Sunset Garden Senior Living Apartments

SITE PLAN 236 UNITS
1" = 40'

PRCP20260223

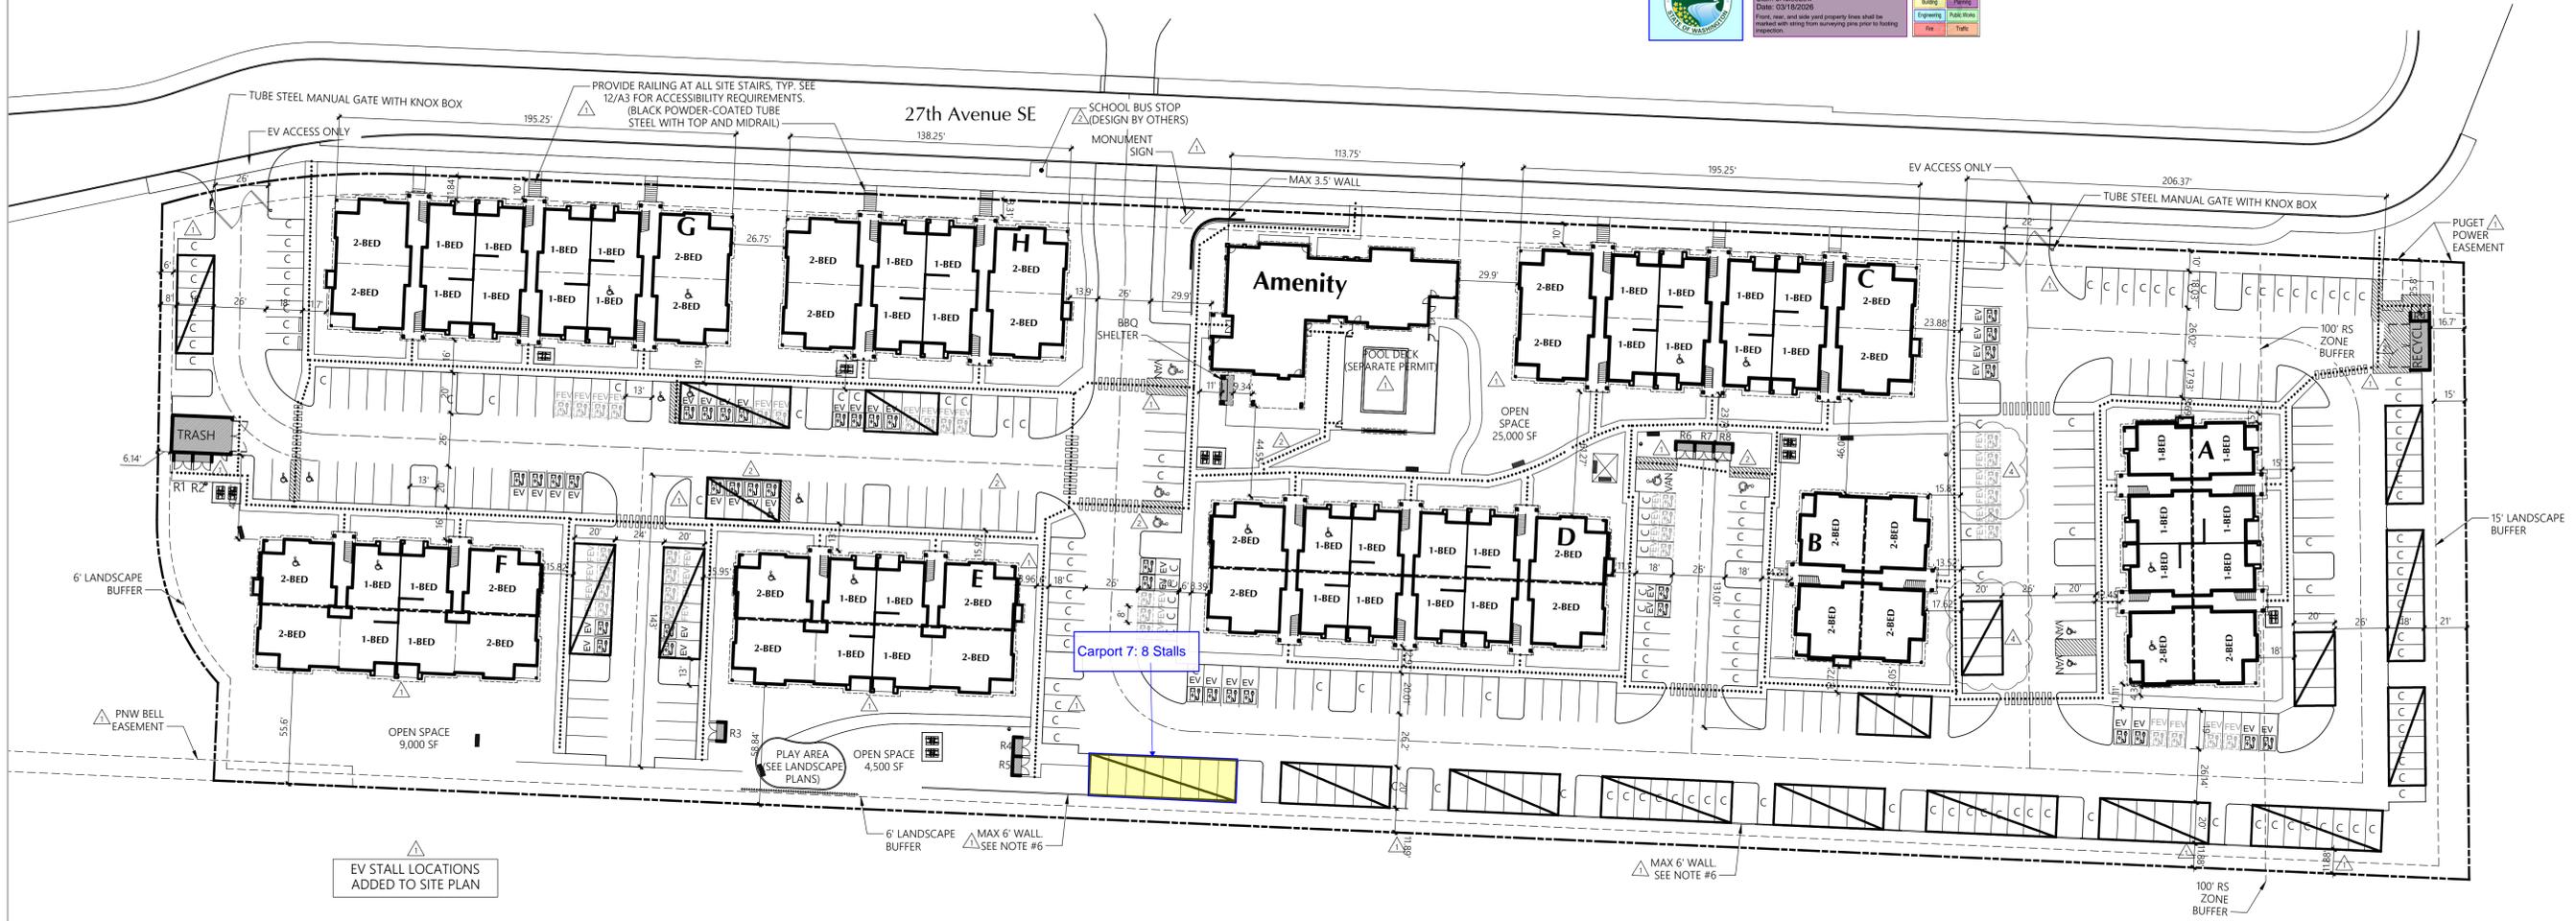
PARKING COUNTS CORRECTED
